Subject: Duke Energy Carolinas, LLC
William States Lee III Nuclear Station - Docket Nos. 52-018 and 52-019
AP1000 Combined License Application for the
William States Lee III Nuclear Station Units 1 and 2
Response to Request for Additional Information
(RAI No. 4961)
Ltr# WLG2010.09-05

Lee Nuclear Station Response to Request for Additional Information (RAI)

RAI Letter No. 092

Reference NRC RAI Number(s): RAI 02.03.04-006

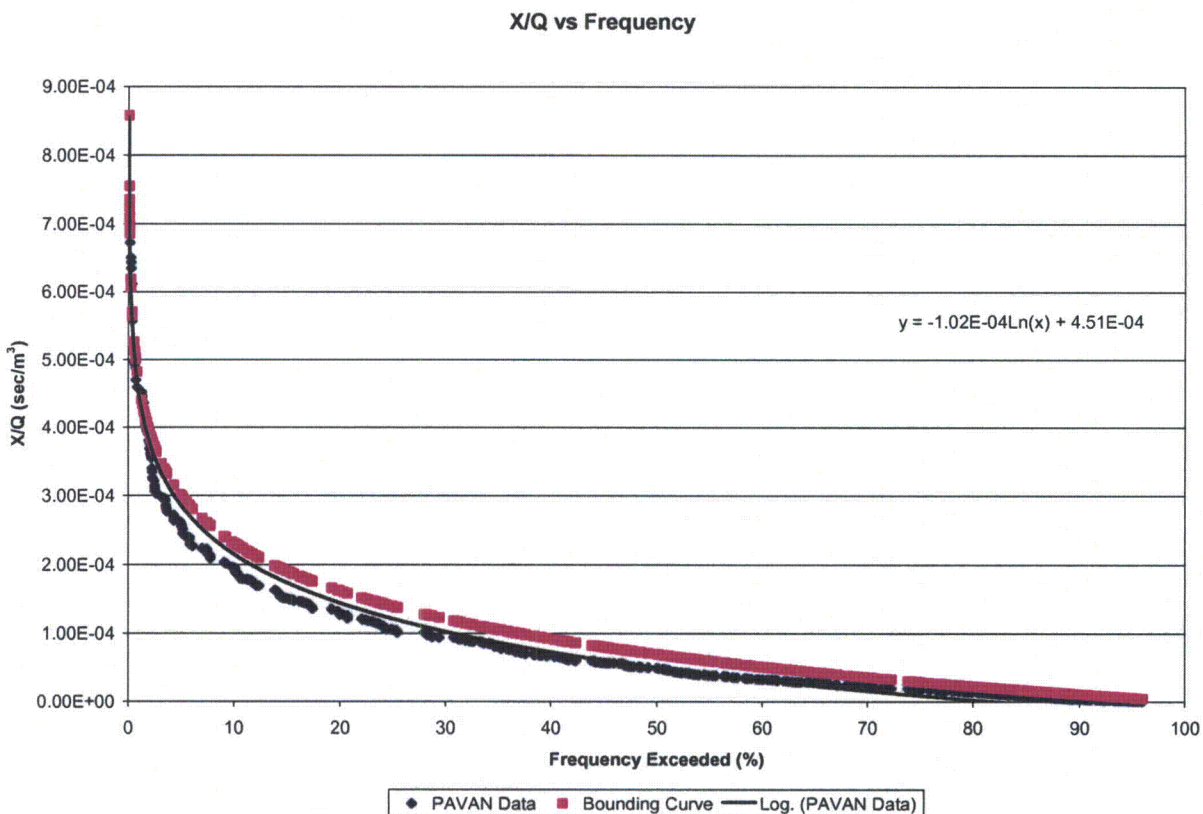
(c) The proposed revisions to COL FSAR Table 2.3-283 indicate a revised 5 percent Overall Site Limit 0-2 hour X/Q value for the Exclusion Area Boundary (EAB) of $3.00E-04 \text{ sec/m}^3$. On reviewing the PAVAN output file "LEE2YR15.OUT", included as one of the files on the CD provided as Attachment 1 of the RAI Response, that value does not appear in the summary table at the end of the EAB modeling results. All Site Limit X/Qs are reported as "0.00E+00" for the short-term accident time intervals. Further, the ordered distribution of "Five Percent Overall Site Limit" X/Q values, earlier in the referenced output file, does not suggest the revised value listed in Table 2.3-283. The last line of that segment of the PAVAN model output lists an error message "ERROR IN SUBROUTINE ENVLOP". Regulatory Position C.4 in Regulatory Guide 1.145 states that the X/Q value for Exclusion Area Boundary evaluations should be the maximum sector X/Q determined in accordance with Regulatory Position 2, or the 5 percent overall site X/Q determined in accordance with Regulatory Position 3, whichever is higher. Given the above and that there is no explanation in the proposed revision to COL FSAR Section 2.3.4.2 regarding the basis for the "5 percent direction independent overall site dispersion at the EAB" as listed on revised Table 2.3-283 (Sheet 1 of 2), explain how the higher of the "0.5 percent direction dependent maximum sector relative dispersion" and the "5 percent direction independent overall site dispersion at the EAB" was determined, as listed on revised FSAR Table 2.3-283 (Sheet 2 of 2) and summarized at the end of Section 2.3.4.2, as proposed to be revised.

(c) FSAR Subsection 2.3.4.2 discusses the comparison of the direction dependent and the direction independent χ/Q values for the Exclusion Area Boundary (EAB) and Low Population

Zone (LPZ). Regulatory Position 4 of Regulatory Guide 1.145 requires that the EAB and LPZ χ/Q values be calculated based on both a directionally independent methodology (overall site limit) and a directionally dependent methodology (maximum sector), and that the most conservative (highest) values be chosen. However, due to limitations of the PAVAN computer code, the EAB overall site limit is not calculated when an irregular EAB is used. This limitation is indicated by the message "Error in Subroutine ENVLOP" that appears in the output file. As a result, the overall site χ/Q (direction independent) value which was equaled or exceeded 5.0% of the time was manually calculated using Microsoft Excel, based on the upper envelope of the ordered χ/Q frequency values extracted from the PAVAN output file. The ordered χ/Q values for the EAB and the frequency that the values are reached or exceed were obtained from the PAVAN output file, LEE2YR15.OUT. The χ/Q values were plotted versus the frequency (see figure below), and an equation for the curve was determined using the Microsoft Excel logarithmic trend line function. The coefficient of the natural log and the intercept for the curve were then adjusted slightly to obtain the equation for a bounding or enveloping curve for the EAB. The equation of this bounding curve was then used to determine the 5% overall site limit χ/Q values for the EAB.

The equation shown above is the curve fit for the PAVAN data. The equation for the bounding curve is:

$$y = -1.0E-04 * \ln(x) + 4.61E-04$$

which gives a 5% overall site limit atmospheric dispersion value of $3.00E-04 \text{ sec/m}^3$.
